**REQUEST TO CHANGE PEET FLAGSTONE PDA DEVELOPMENT APPROVAL DEV2023/1414
SECTION 99 OF ED ACT – FLAGSTONE CITY: CA3 SOUTH – SCHOOL RAL (DEV2023/1414)**

It is proposed to make a minor amendments to the latest approval package issued by EDQ on 18 December 2025 (EDQ Ref: DEV2023/1414), pursuant to Section 99 of the *Economic Development Act 2012* (the Act).

Table 2: Proposed changes to Stage 2 layout

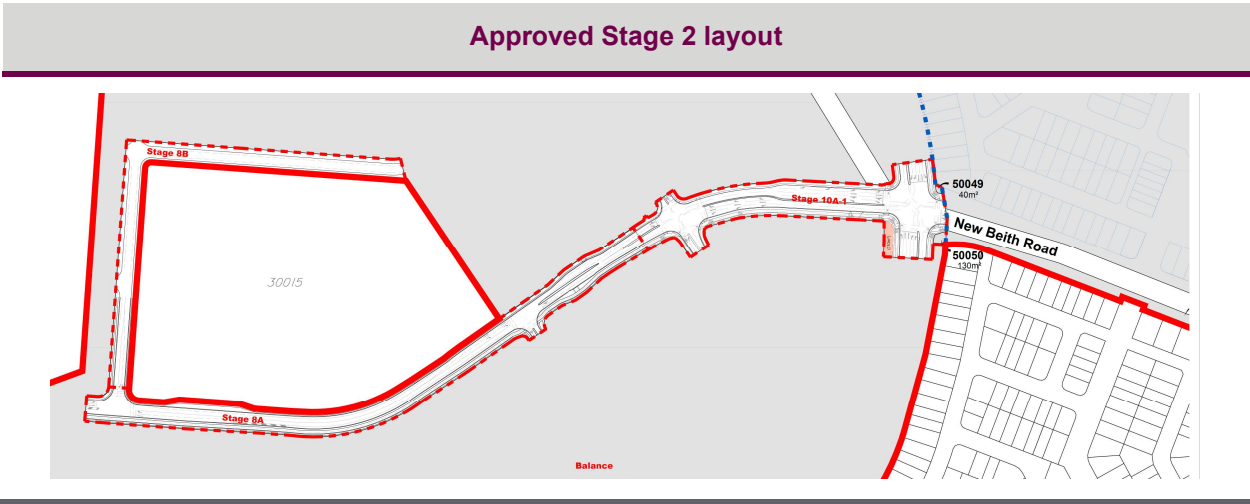
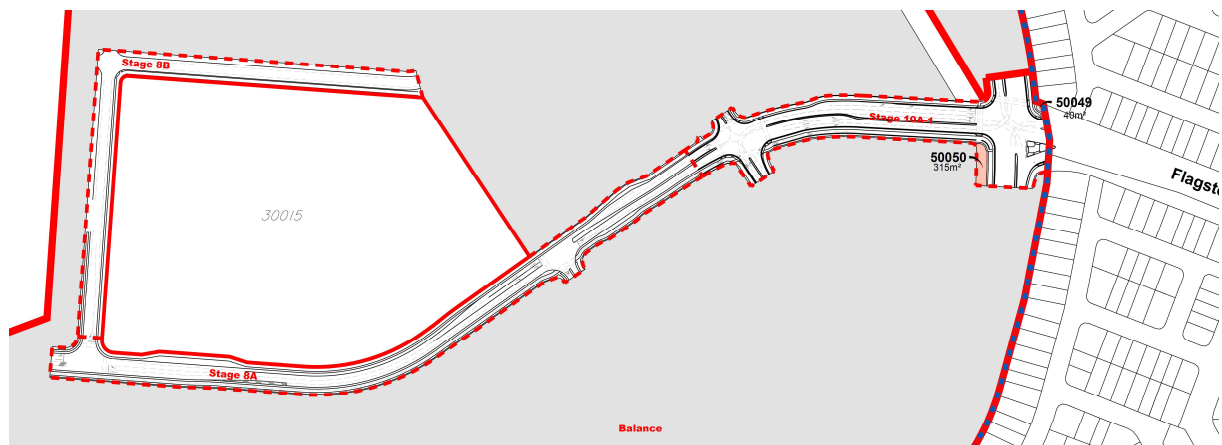
Stage 2 of the School RAL is proposed to be amended to reflect the revised road network providing access to the school site. The road network is established as part of the CA3 South Change application that was recently lodged to EDQ. The road network in this part of the site is approved and will not be changed again as part of further applications due to its imminent delivery.

In particular, the following changes to the CA3 South road network have been included within the School RAL layout plans:

- 20.2m wide Neighbourhood Connector amended to 21m in width to the north and west of the school site.
- 23.7m wide Trunk Connector (Flagstonian Drive extension) amended to 23.8m in width to the south of the school extending to the Flagstonian Drive / New Beith Road intersection to the east.

- Changes to the functional design of Flagstonian Drive design south of the school site as a consequence of changes to the CA3 South approval.
- Changes to the Flagstonian Drive / New Beith Road intersection to the east based upon detailed design, intersection capacity requests from EDQ and advice from Logan City Council.

- Removal of the entry statement lot (Lot 50050) on the south-eastern corner of the intersection because of changes to the slip lane design.
- Inclusion of a small allotment (Lot 50050) for the containment of the Wyaralong interconnector along the alignment of New Beith Road to the south-west of the intersection.

- Changes to the balance land within Stages 2-5 of Flagstone to account for the delivery of Stage 5T which the section of Flagstonian Drive which provides access to CA3 South.
